# MONITORING YEAR 4 ANNUAL REPORT

## OWL'S DEN MITIGATION SITE

RE: Owl's Den Mitigation Site-Year 4 Monitoring Report  
Final Submittal for DMS  
Contract Number 004673, RFP Number 16-004110, DMS# 95360  
Yadkin River Basin – CU# 03040105; Union County, NC

Wildlands Engineering, Inc. (Wildlands) has reviewed the Division of Mitigation Services (DMS) comments and observations from the Owl's Den Mitigation Site Draft Year 4 Monitoring Report. Wildlands walked the site on 1/7/2019 to evaluate the site condition after the beaver dam was removed. Wildlands confirmed that the streams are stable and that monitoring features have not impacted by the beaver dam. The report text has been revised for the final draft to reflect the most current condition of the site. The following are Wildlands responses to your comments and observations from the report noted in italics lettering.

Wetland Rehabilitation

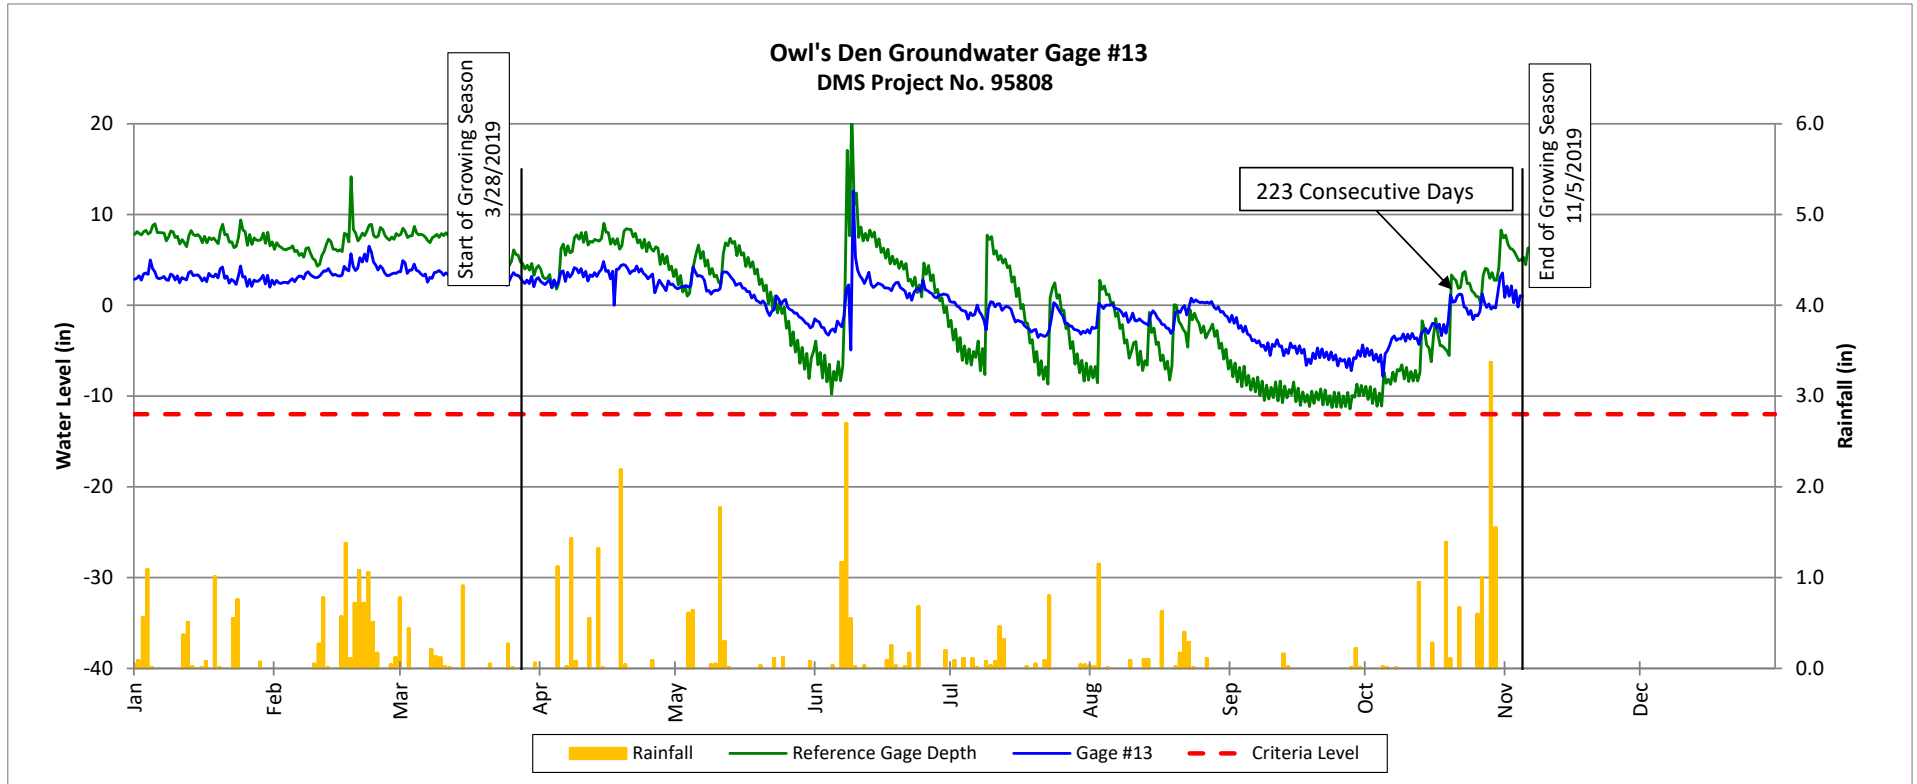
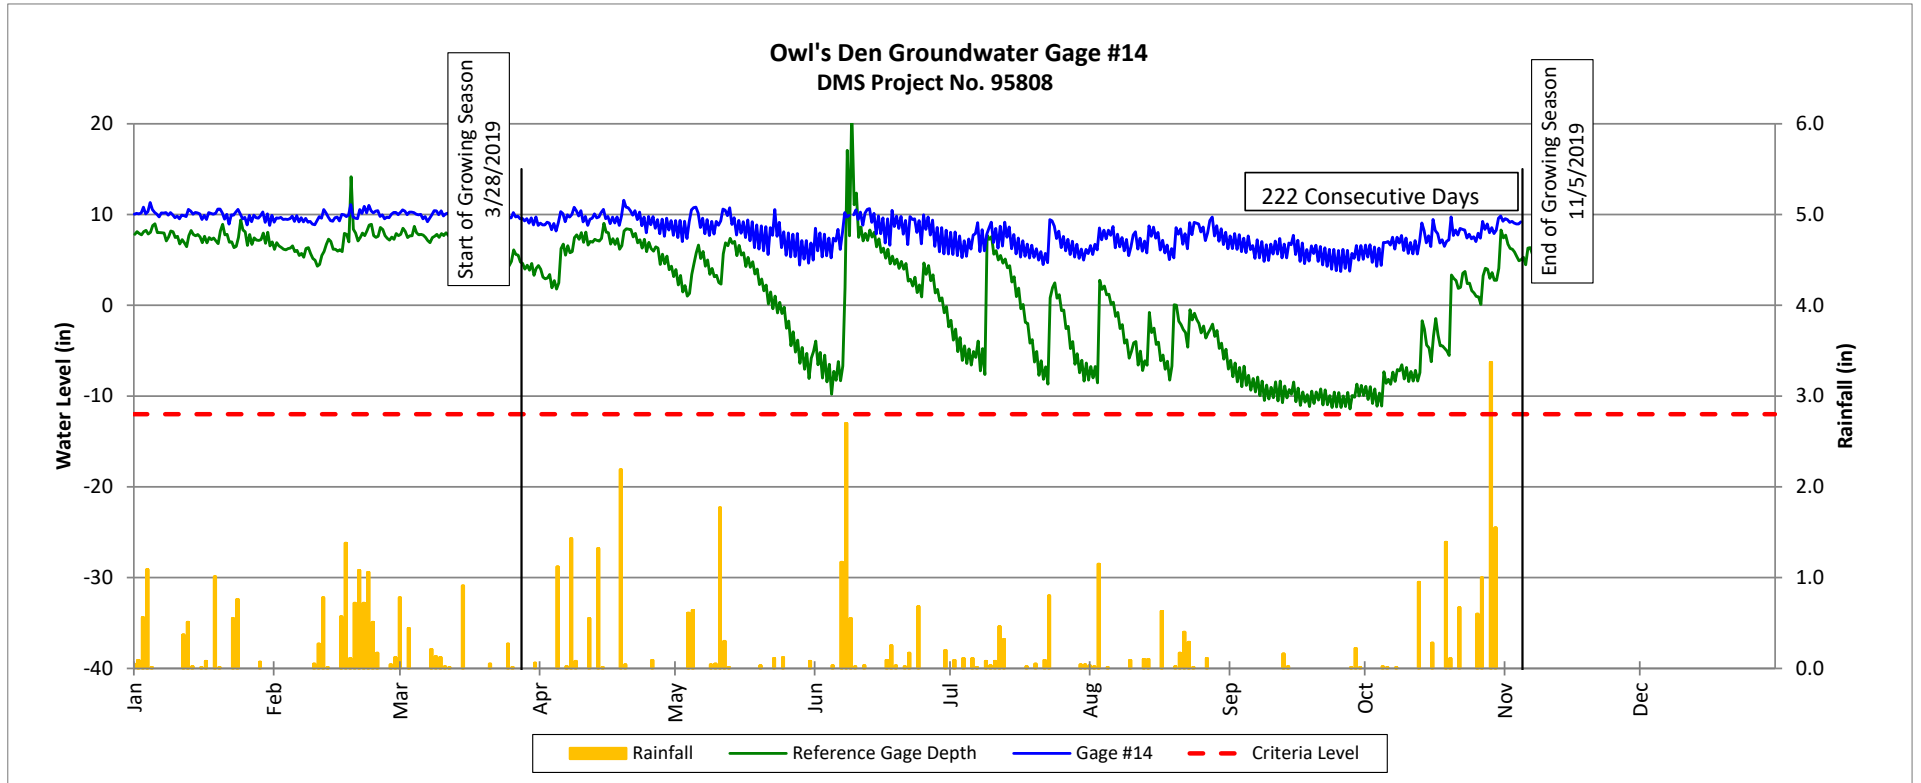
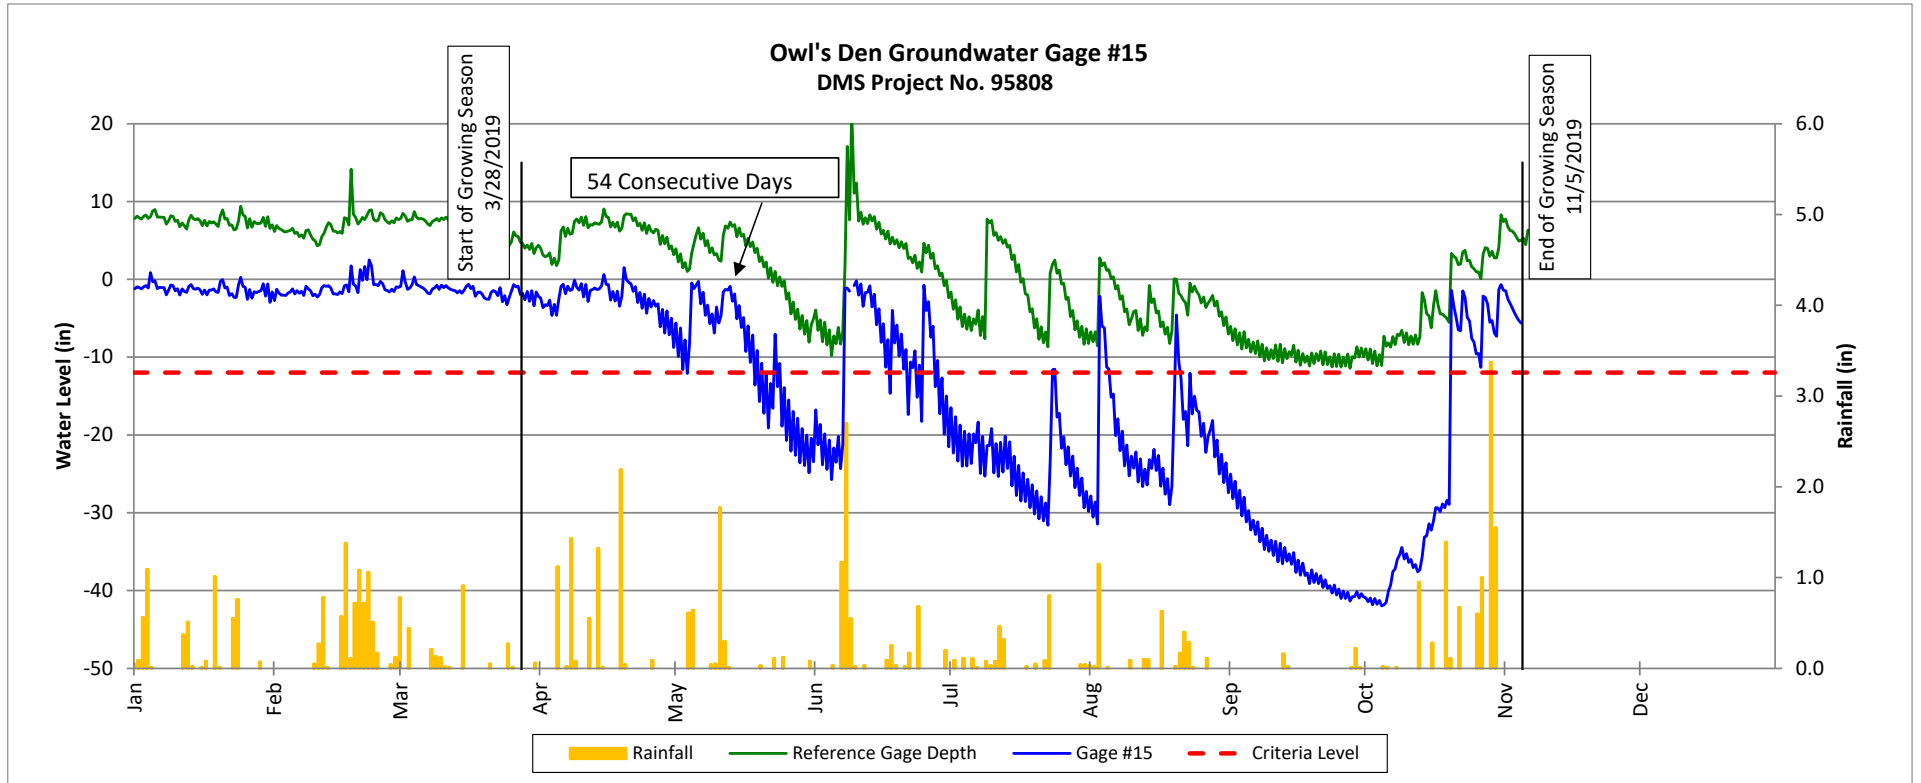
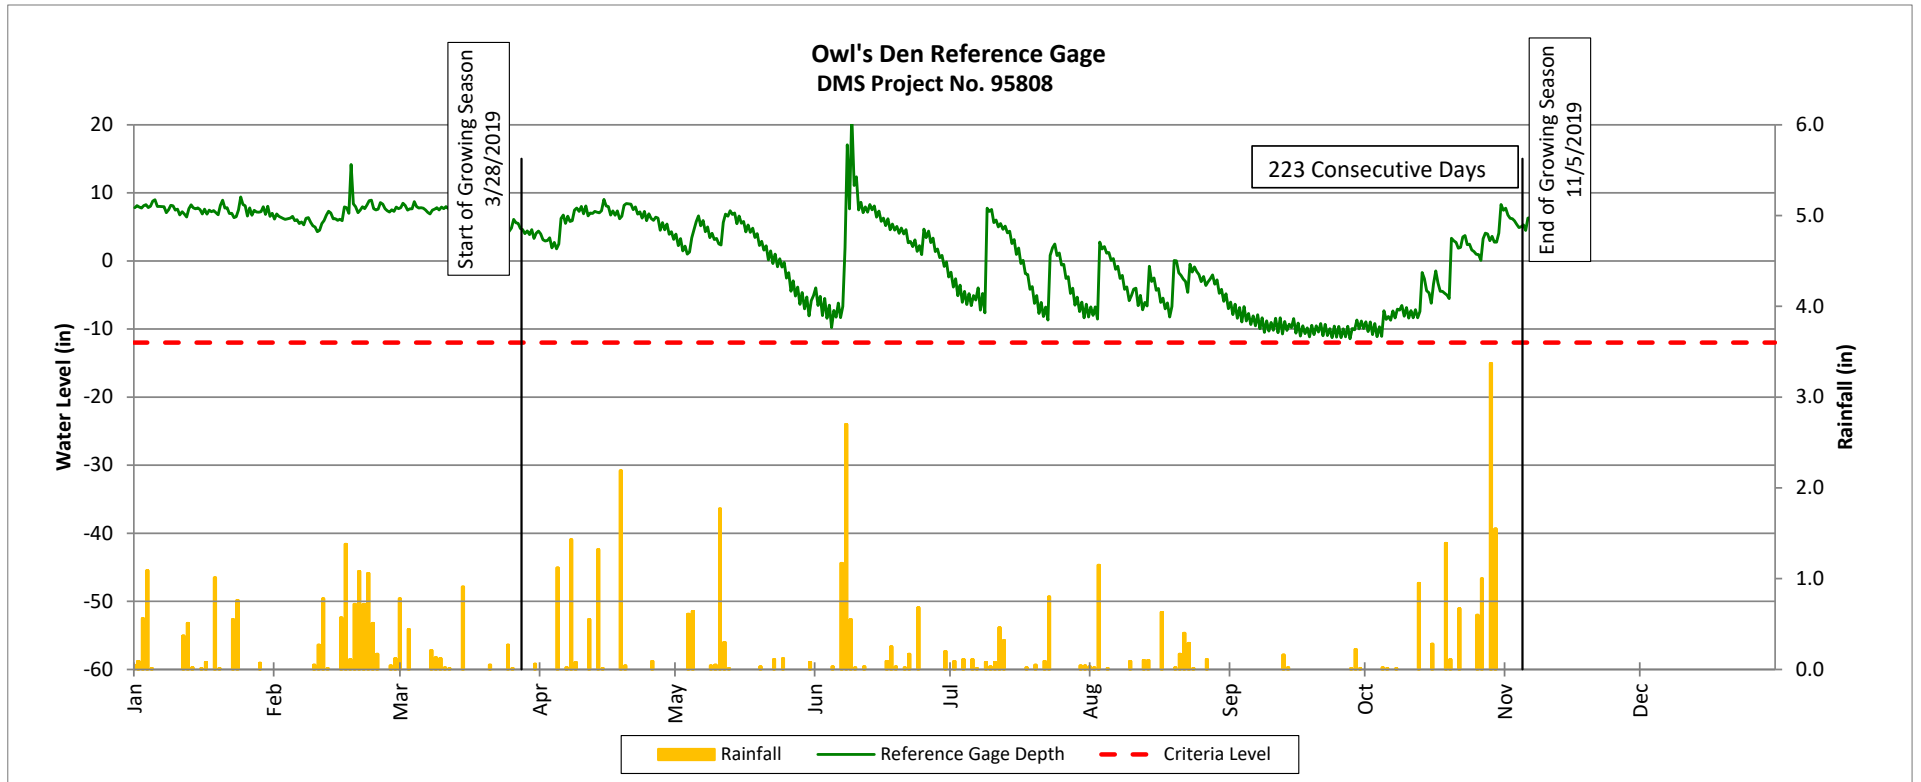
**DMS Comment; Groundwater gage plots: For clarity, consider adding the consecutive day number for each gage on the groundwater gage plots instead of using the currently shown 18-day bar. The 18-day bar adds some confusion to the plots without a description of what it corresponds to (8.1% of the growing season).**

*Wildlands Response; The consecutive number of days meeting criteria was added to each groundwater gage plot and the 18-day bar was removed.*
